UNITED STATES PATENT AND TRADEMARK OFFICE

APPLICATION NO.	FILING DATE	FIRST NAMED INVENTOR	ATTORNEY DOCKET NO.	CONFIRMATION NO.
09/777,122	02/05/2001	Heinz Greiner	188.463	2422

## Office Action Summary

## DETAILED ACTION

FIG.8

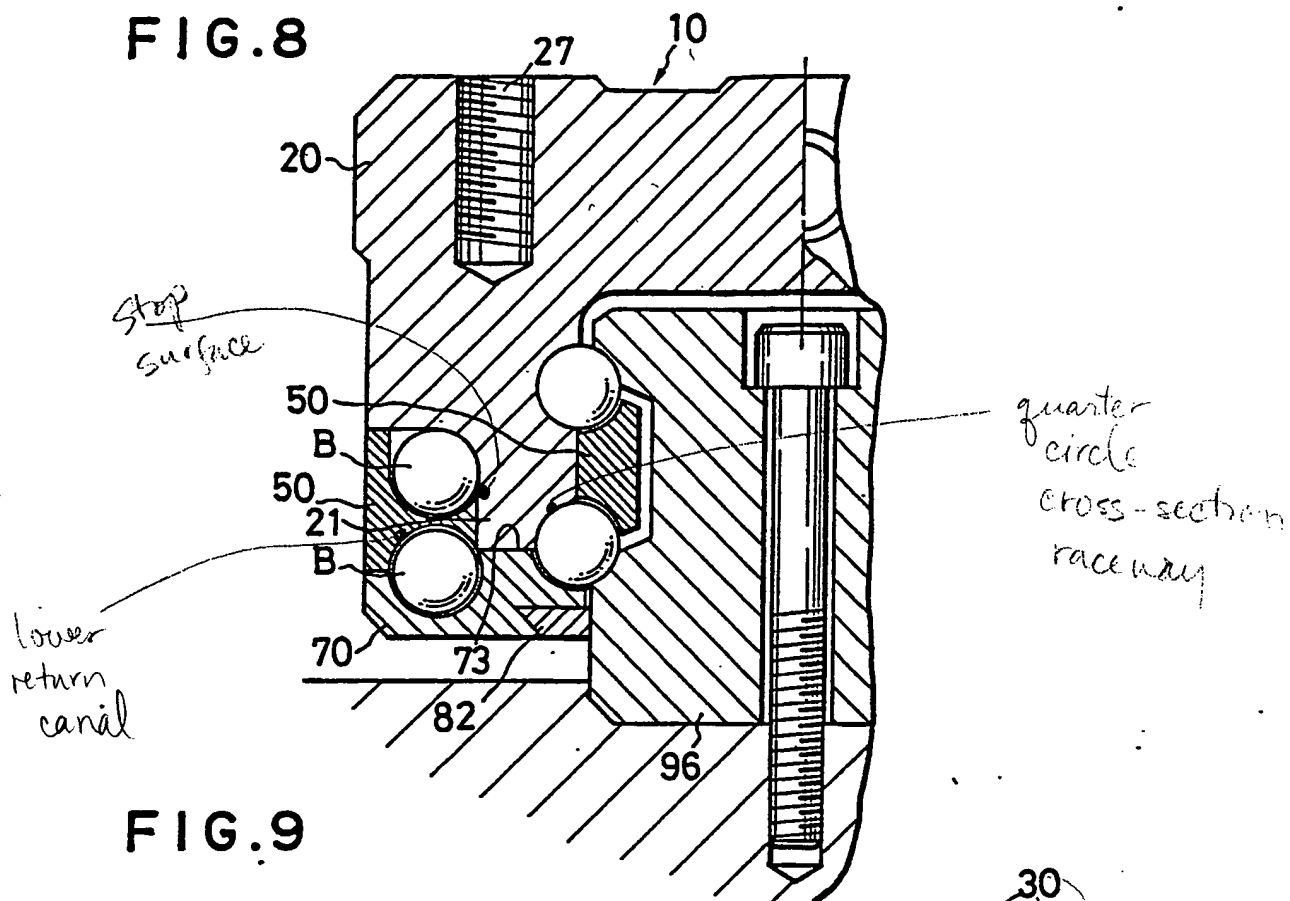
Re: claims 1, 2 and 7, Tonogai shows a linear rolling bearing, as in the present invention, comprising: a guide carriage with a U-shaped cross section in figure 8 having a U-crossbar and two U-legs so that the guide carriage forms a carriage cavity and

Re: claim 6, figure 8 shows the opening of the lower return canal to be smaller than the diameter of the balls inserted in the return canal (see attachment #1).
